From Saab Cars 2002 04 03

Subject: New 9-3 and 9-5 Manual Transmission Fluid

Looking In From Left Wheel

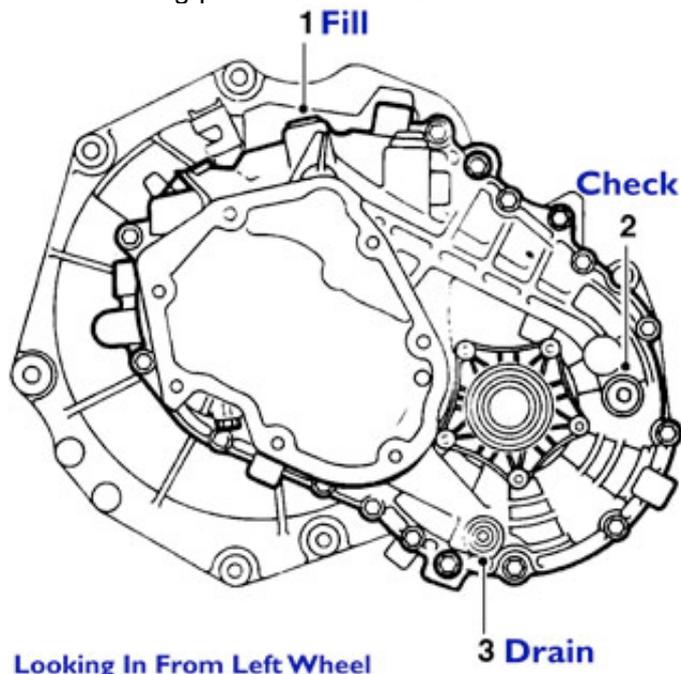
In addition, manual transmissions for 1994 and later models that have been rebuilt in Sweden will have the new fluid added. These transmissions will be identified by a label marked "MTF 0063" attached to these transmissions.

The new fluid will improve shift quality. It can be used to address shift complaints on previous 9-3 and 9-5 models, if the following procedure is used.

1. Completely drain oil from gearbox
2. Fit drain plug and add 1.5 liter of new MTF 0063 fluid
3. With front wheels off the ground, start the engine, engage first gear and run for approx. 20 seconds.
4. Repeat steps 1-3.
5. Drain and refill with 1.5 liters of MTF 0063 fluid
6. Total fluid used for this process, including final fill is 4 ½ liters.
